### AGENDA FOR THE REGULAR MEETING OF THE DESIGN REVIEW SUBCOMMITTEE

Wednesday, December 11, 2013 10:00 a.m.

Community Development Department Conference Room A 910 Calle Negocio, Suite 100 San Clemente, CA 92673

Monument Sign Specifications

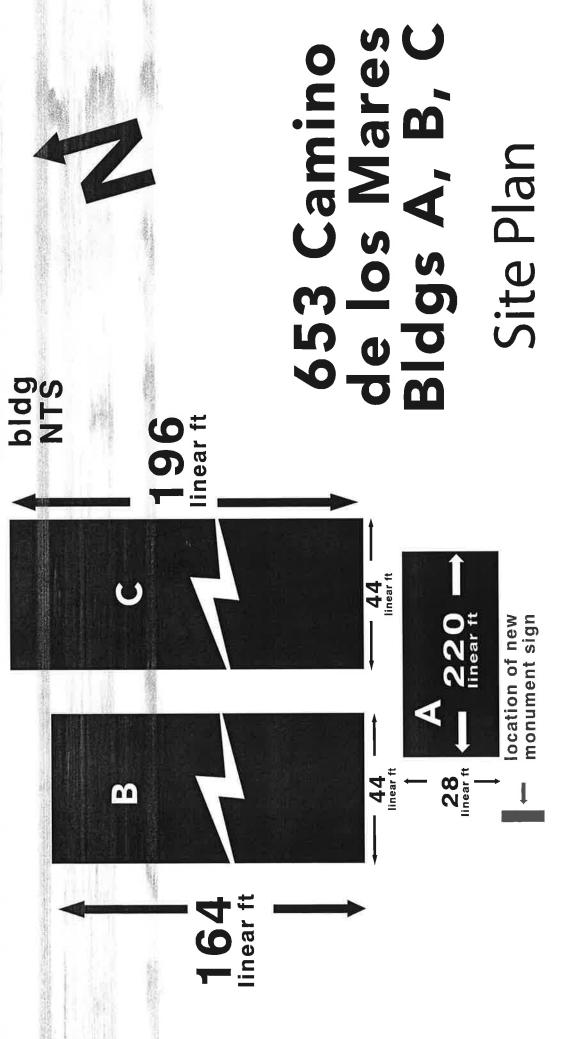
**Dark Brown Sign Faces-**Instead of the black sign faces like the applicant is showing, staff recommends utilizing a dark brown to match the trim and wood trellis color of the buildings. This slight color variation will further tie the monument sign with the buildings.

**Base of the Monument Sign-**To break up the massing so it is not just a square, there are a variety of ways in which the base can be expanded or columns potentially added to provide some additional aesthetic design, depth, and relief.

**Plaza Name Plate-**The top name plate is too small to accommodate the font. Therefore, the font size should either be reduced or the space enlarged so the proportions are in balance. Additionally, with other sign modifications, the Plaza's name may have other ways it could be displayed to identify the site.

VALERO FRONT ELEVATION (SOUTH)

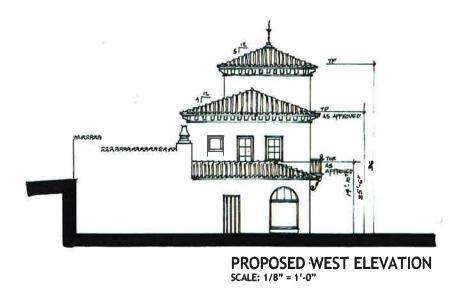
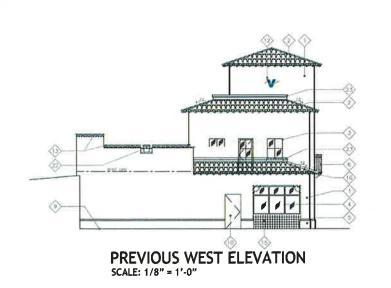
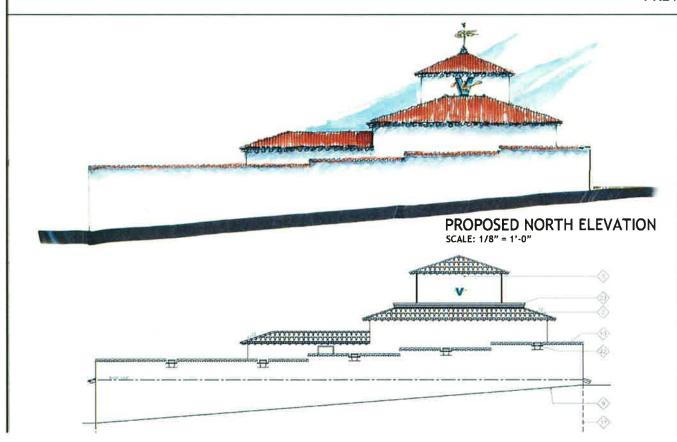
- 1. <u>Tower height-</u>The tower height has increased an undetermined amount with the change in proportionalities of the entry. A wind vein with the Valero V is proposed for the top.

- 2. <u>Entry tower balcony-</u>The balcony has been modified from a larger in set balcony, to a smaller Juliet style balcony.
- 3. **Storefront windows-**In place of the large bay of windows, the space has been broken up into smaller portions set back in arches and columns.

- 4. <u>Signage on the tower-</u>It appears that the signs on the tower are hand painted rather than pin mounted and halo lit. This needs to be clarified.

- 5. <u>Removal of visible parapets-</u>A parapet wall was visible above the red tile roof, that has now been removed and only the red tile roof is visible.

POLE SIGN DESIGN OPTION A

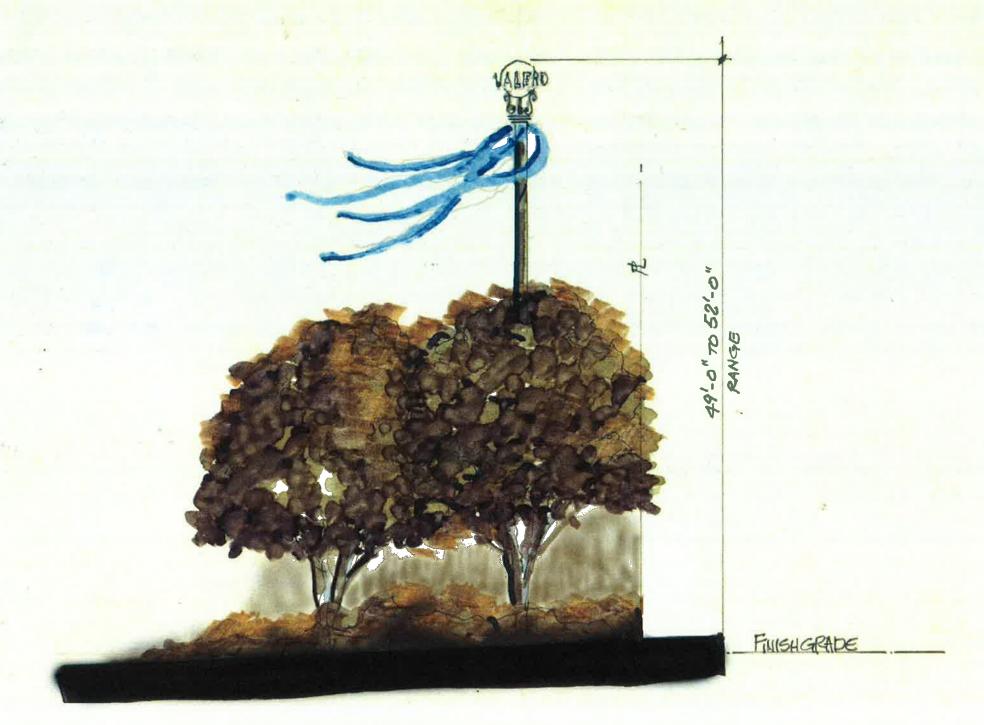
- 6. <u>Pole sign-</u>The applicant is now proposing to remove the pole sign, and locate a new pole sign towards the back of the property, next to the offramp, at a height of approximately 49 to 52 feet. The design is unique and the uses of material strips are reminiscent of signage used for Paseo Nuevo in Santa Barbara. The applicant's first choice is option A, but they have provided an option B for discussion as well.

#### **EXISTING SIGNS**

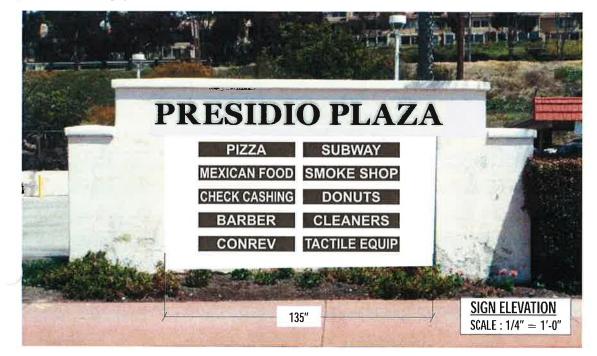
The applicant proposes to remove the 43 square-foot painted script with neon sign on the central tower element and replace it with a 28.5 square foot halo-lit aluminum, reverse-channel letter sign with a traditional serif font that matches the center identification signs of the monuments. The proposed finish is a duranodic bronze color.

By replacing the neon sign with a metal halo-lit sign, the proposed modification is more compatible with Zoning Ordinance Section 17.84.20(C), Design of Signs within an Architectural Overlay District, as well as the buildings across the street that are in the Architectural Overlay. The removal of the script font also creates more consistency in the shopping center's signage, while reducing the center's total signage.
